VIRGINIA ELECTRIC AND POWER COMPANY  
RICHMOND, VIRGINIA 23261

May 19, 1981

FIRE PROTECTION INFORMATION  
SURRY POWER STATION

SURRY POWER STATION  
FIRE PROTECTION INFORMATION

**FLOW DIAGRAM  
CHEM & VOLUME CONTROL  
SHEET-2**

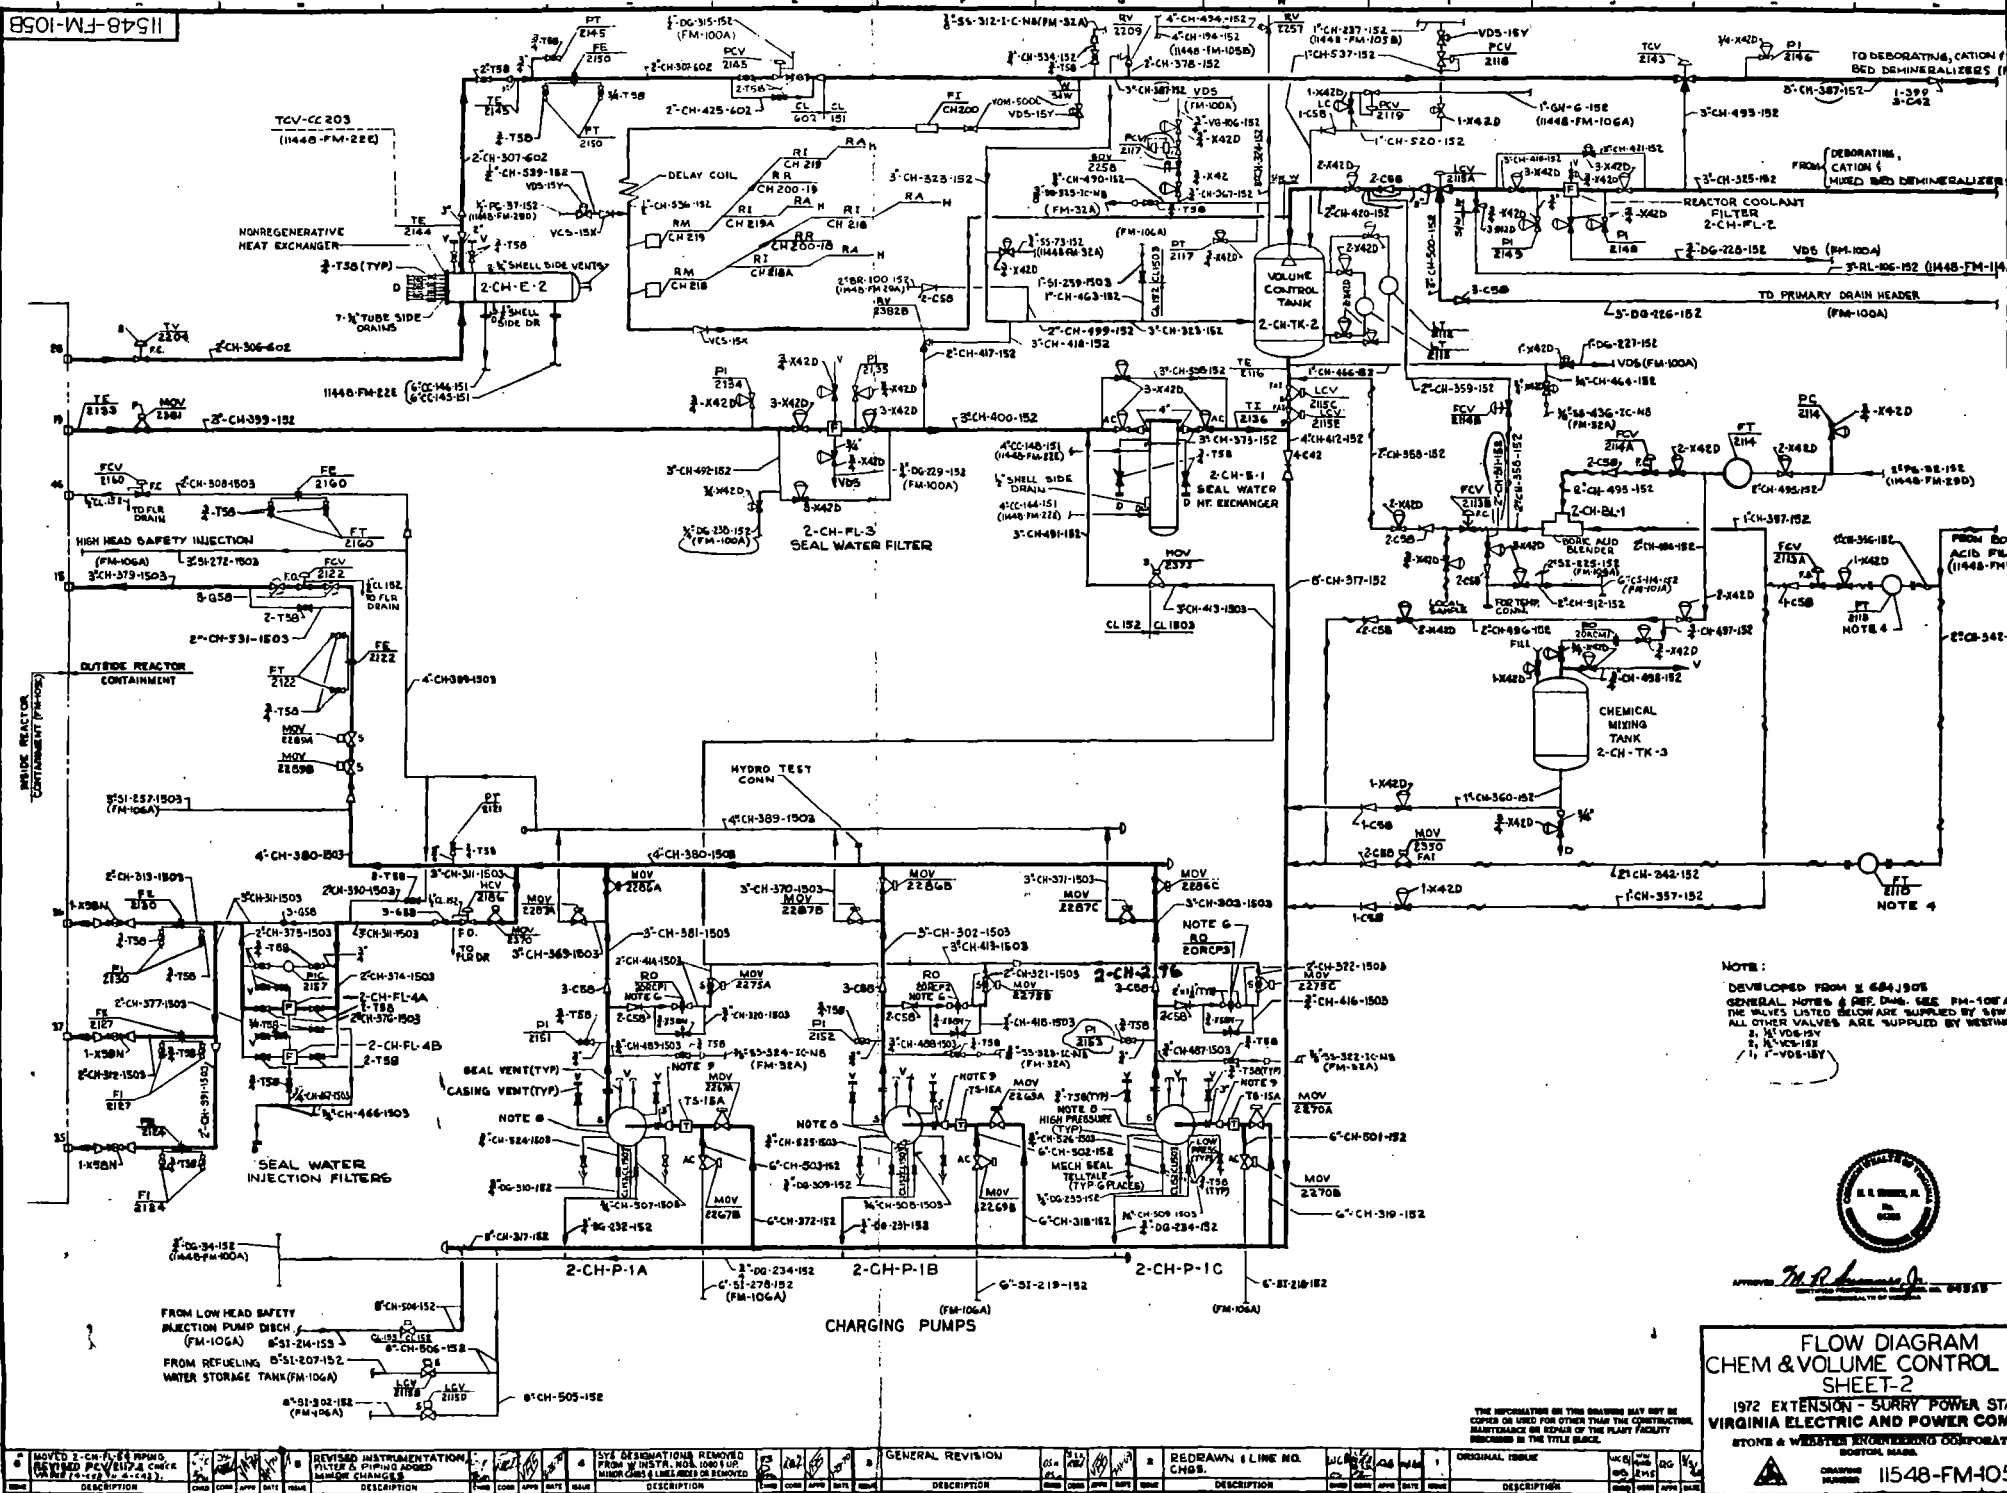
- A. The alternative shutdown capability meets the requirements of Section III.L of Appendix R to 10CFR Part 50. Design descriptions of the alternate shutdown systems were submitted by Vepco letters Serial Nos. 869 and 885 dated October 29, 1980 and October 31, 1980. However, the tie-in point of the Unit 1 and Unit 2 charging pump cross connect has been modified. The new tie-in point is inside MOV 1286C/MOV 1287C and MOV 2286C/MOV 2287C as shown on the attached sketch.

The charging pump cross connect tie-in to both units is between "C" charging pumps and the "C" pumps discharge MOVs. The purpose for this new location for the tie-in is:

- a. To facilitate a possible future modification of tying opposite units charging pump suction lines together as a result of degraded core procedures being developed to give operations more flexibility in the event of failed fuel accident along with loss of all three charging pumps.
- b. "C" charging pumps have dual power feeds and "C" pump could be dedicated to the cross connect and the disabled unit by closing the "C" discharge MOVs.

3.1.25 CHARGING PUMP CROSS CONNECT

Vepco letter Serial No. 869 dated October 29, 1980 submitted design description of the charging pump cross connect. Prior to installation of the system a modification was made in regard to the tie-in location of the cross connect piping. The attached sketch shows the new arrangement. The advantages of the new tie-in location is as follows:

- a. "C" charging pumps have dual power feed and "C" pump could be dedicated to the cross connect and the disabled unit by closing the operating "C" charging pump MOVs.
- b. Facilitates a possible future modification of tying Unit 1 and 2 "C" charging pump suction lines together to give operations more flexibility in dealing with events other than fire that could affect high head safety injection.
